THE MARYLAND-NATIONAL CAPITAL PARK AND PLANNING COMMISSION

MEMORANDUM

REVIEW TYPE: Site Plan Review concurrent with Preliminary Plan Review
APPLYING FOR: Approval of 12 townhouses 2.17 net acres
PROJECT NAME: Green Hills
CASE #: 8-02033
REVIEW BASIS: Sec. 59-D-3, Zoning Ordinance: Site Plan required in the RT-6 Zone

Compatible Building Locations: **Achieving Acceptable Outdoor Noise Levels, Usable Open Space**

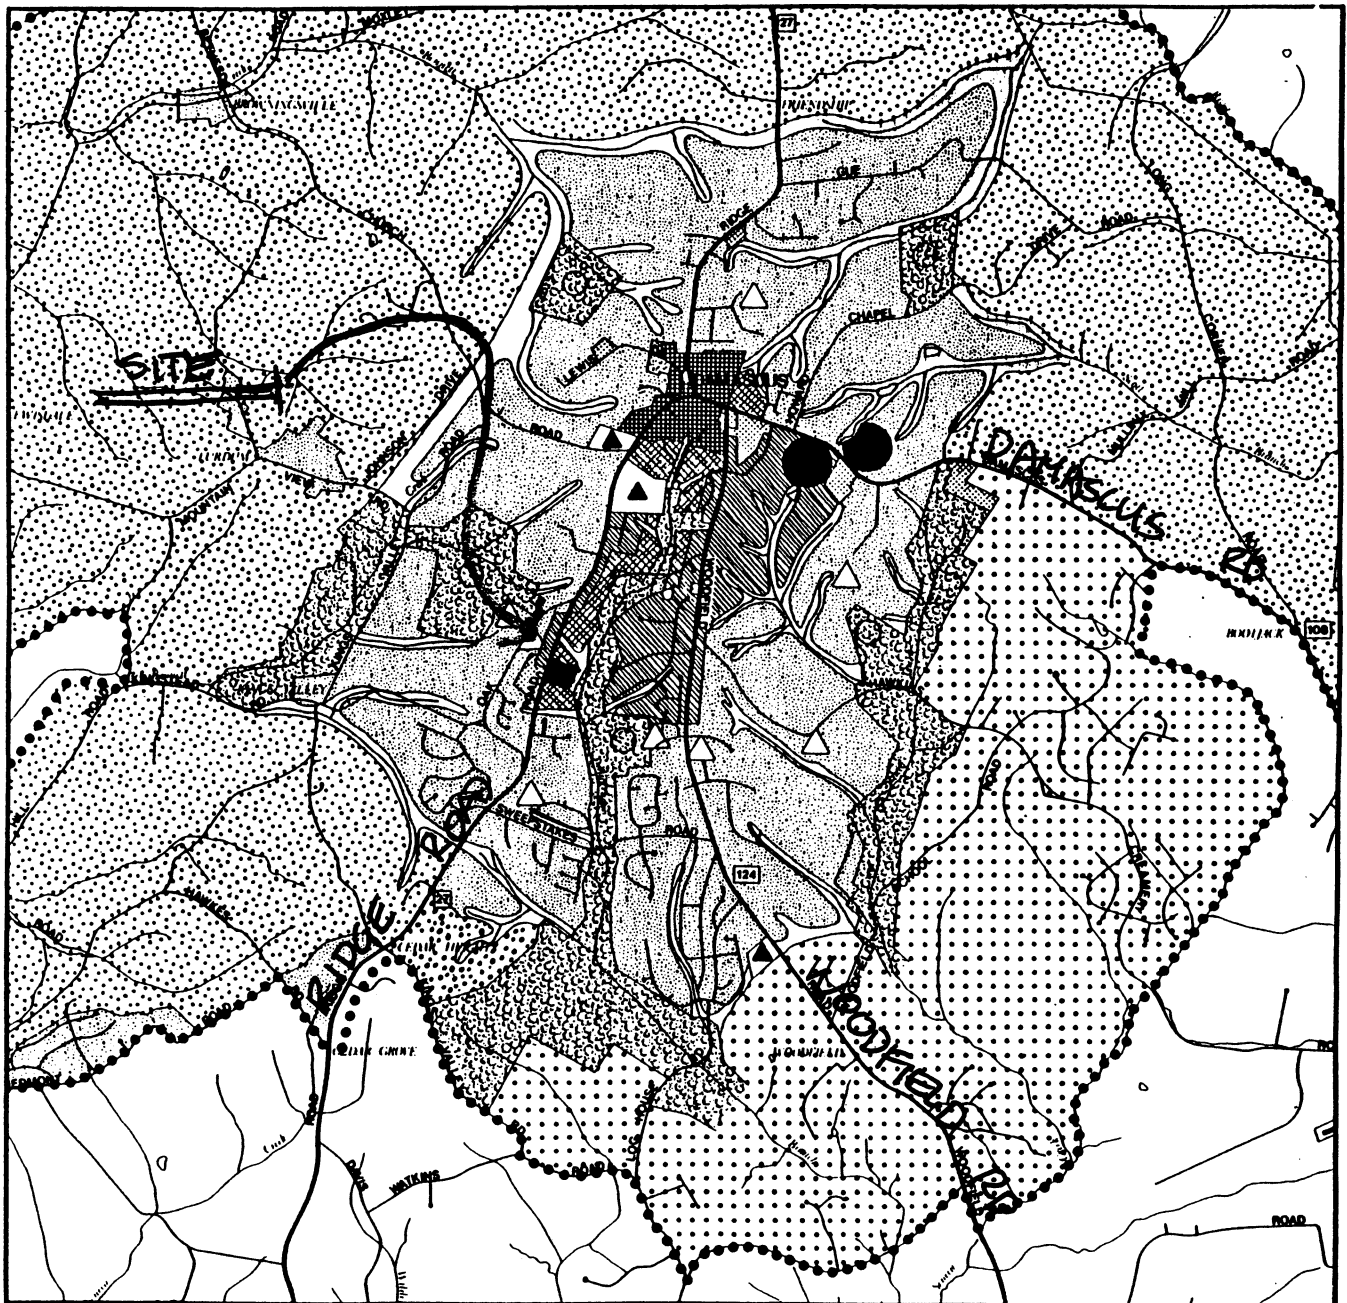
STAFF POSITION: The limited area of the site, its irregular shape, and unusual access conditions impose substantial difficulty in achieving an environment of adequate compatibility. This may be observed acutely in the relationship between the proposed houses and the character of Ridge Road as a major transportation artery. The siting and orientation of the houses on the slope exposes the yards to the excessive noise levels from the heavy stream of traffic and compromises the quality and usefulness of the outdoor space. Relocation of the houses at a lower grade on the slope will achieve a greater level of mitigation, and enhance the outdoor public areas of the site.

- b. **Site Design**:
 - i. Compatibility:
Delete Lot 5 to allow adequate area for the stormwater management facility, permit acceptable vehicular turning radius at end driveways, and to attain adequate noise mitigation in outdoor areas. Shift Units 6-12 to allow better fit for stormwater facility.

- ii. Shift Units 1-4 approximately 20 feet to the east to allow construction of the house foundations at a lower land elevation, to

enlarge the berm along Ridge Road, and to provide effective placement of noise walls for mitigation of existing noise levels;

PROJECT DESCRIPTION: Proposal

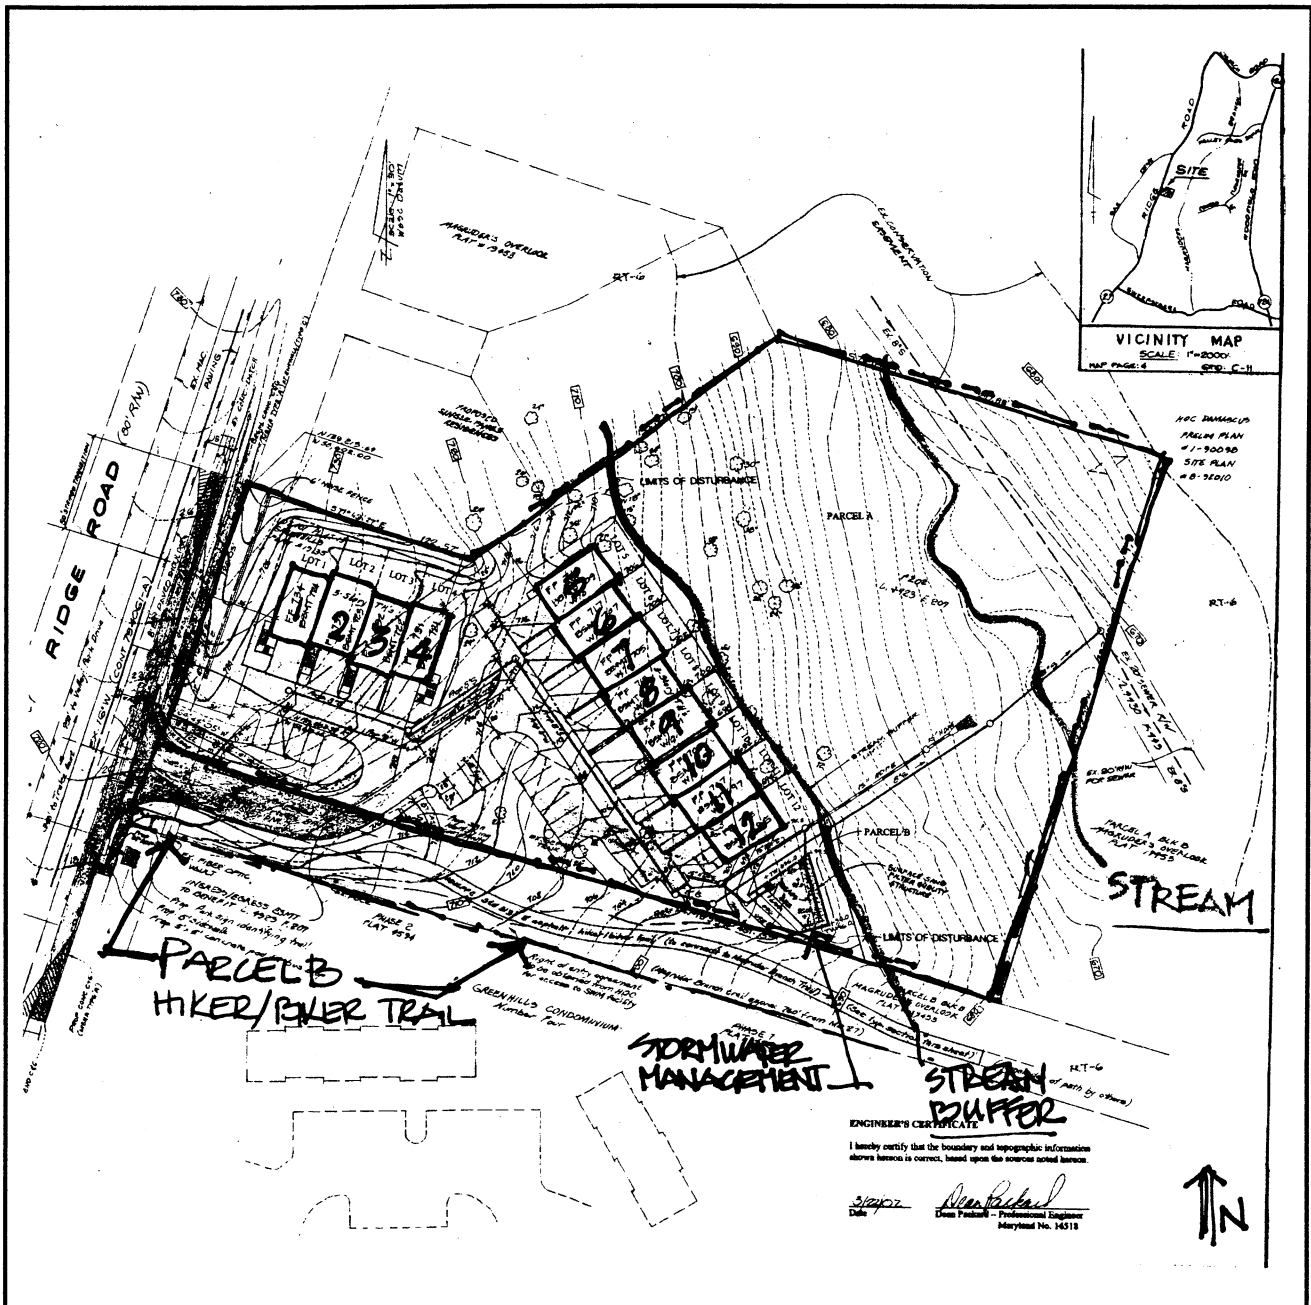
Staff recommends the deletion of one unit from the rear line of houses along the stream buffer for two reasons: first, the elimination of Unit #5 will allow the group of four houses on the hill at the entrance to shift downwards, increasing the effectiveness of noise abatement measures, second, the rear grouping of houses may be slightly shifted northward to provide adequate vehicular access to the stormwater facility and additional useful pedestrian access on site to the stream buffer recreation area.
